**SUBJECT: ISSUANCE OF AMENDMENT NO. 93 TO FACILITY OPERATING LICENSE  
 NPF-38 - WATERFORD STEAM ELECTRIC STATION, UNIT 3 (TAC NO. M88326)**

WATERFORD STEAM ELECTRIC STATION, UNIT 3

Amendment No. 93  
License No. NPF-38

SAFETY EVALUATION BY THE OFFICE OF NUCLEAR REACTOR REGULATION

FIGURE 3.2-2

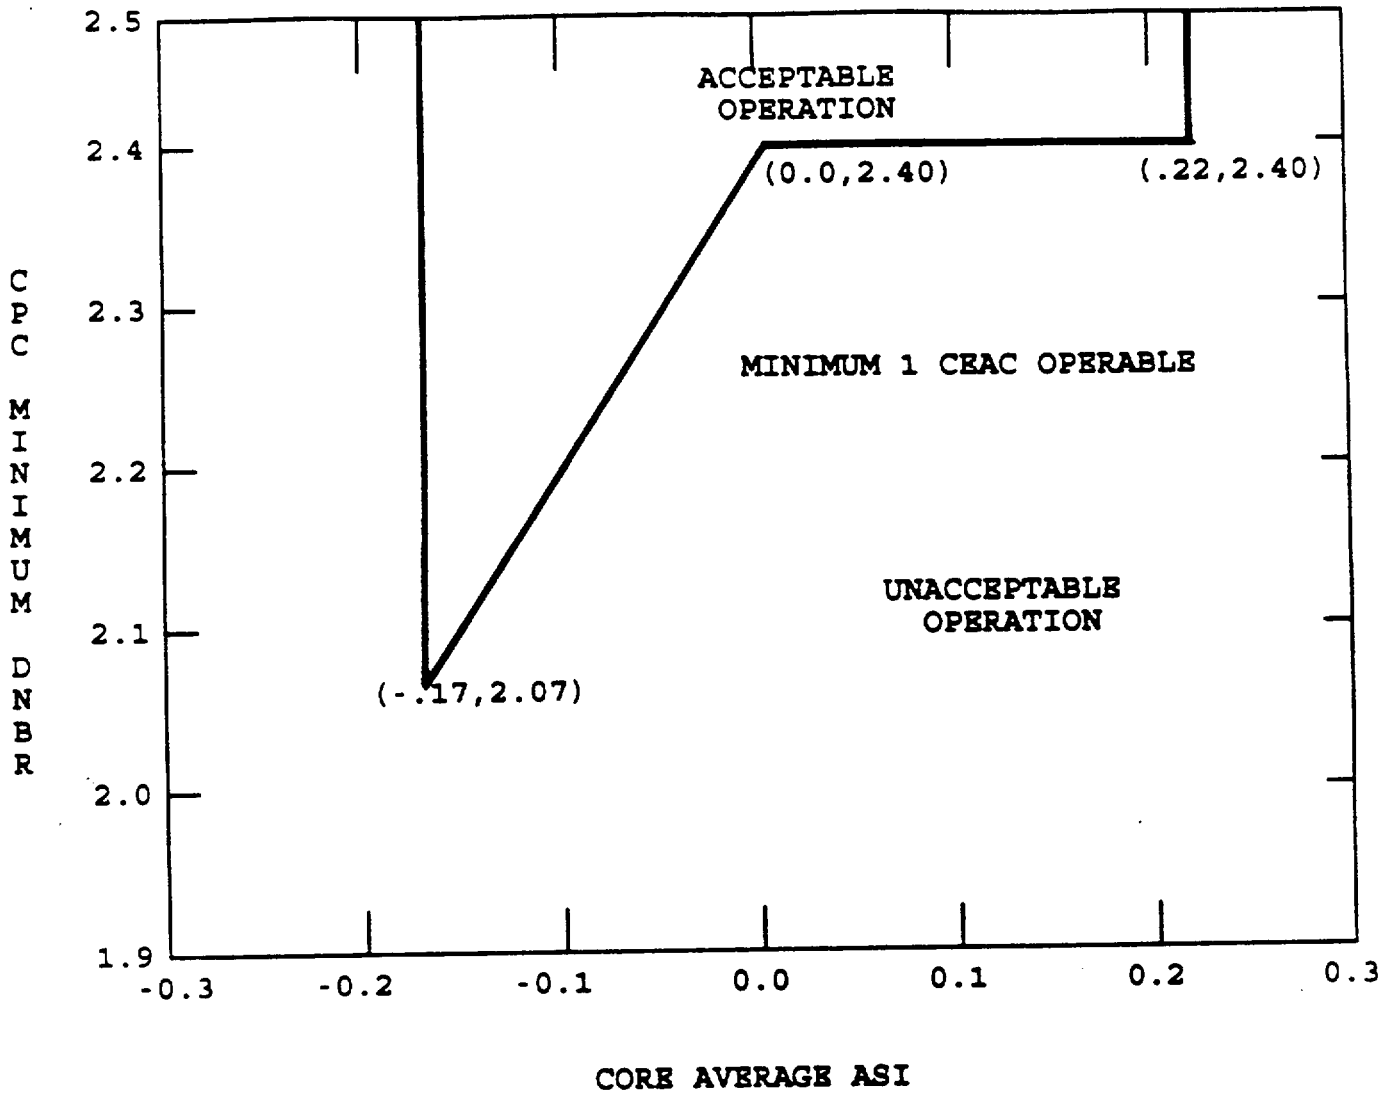
By application dated November 16, 1993, Entergy Operations, Inc. (the licensee), submitted a request for changes to the Waterford Steam Electric Station, Unit 3, Technical Specification (TS) 3.2.4, "Power Distribution Limits, DNBR Margin." The proposed changes (NPF-38-144) would revise TS 3.2.4b (when the Core Operating Limit Supervisory System (COLSS) is in service and neither Control Element Assembly Calculator (CEAC) is operable) and TS 3.2.4c (when COLSS is out of service and either one or both CEACs are operable). By letter dated April 5, 1994, the licensee withdrew the proposed change related to TS 3.2.4b.

When the COLSS is out of service but at least one CEAC is operable, TS 3.2.4c requires that the DNBR operating margin shall be maintained by comparing the DNBR indicated on any operable CPC channel with the allowable value from TS Figure 3.2-2. Whenever the COLSS is out of service, the CPCs are used to perform the same monitoring function. However, the extra conservatisms built into the CPCs for transient protection are not all required when the CPCs are being used for monitoring. In order not to affect the transient protection, these conservatisms are not taken from the CPC but are credited in the COLSS out-of-service limits given in TS Figure 3.2-2.

The licensee has reevaluated the limiting A00s based on the Cycle 7 core parameters as part of the Cycle 7 reload safety analyses. The results have indicated that the acceptable operating region shown in the proposed revised Figure 3.2-2 provides sufficient margin to ensure that fuel failure will not result during normal operation or A00s, thereby conforming to General Design Criterion (GCD) 10 of Appendix A to 10 CFR Part 50. The analyses were performed using staff approved methods and assumptions. The staff, therefore, finds that the proposed revision to this figure is acceptable.
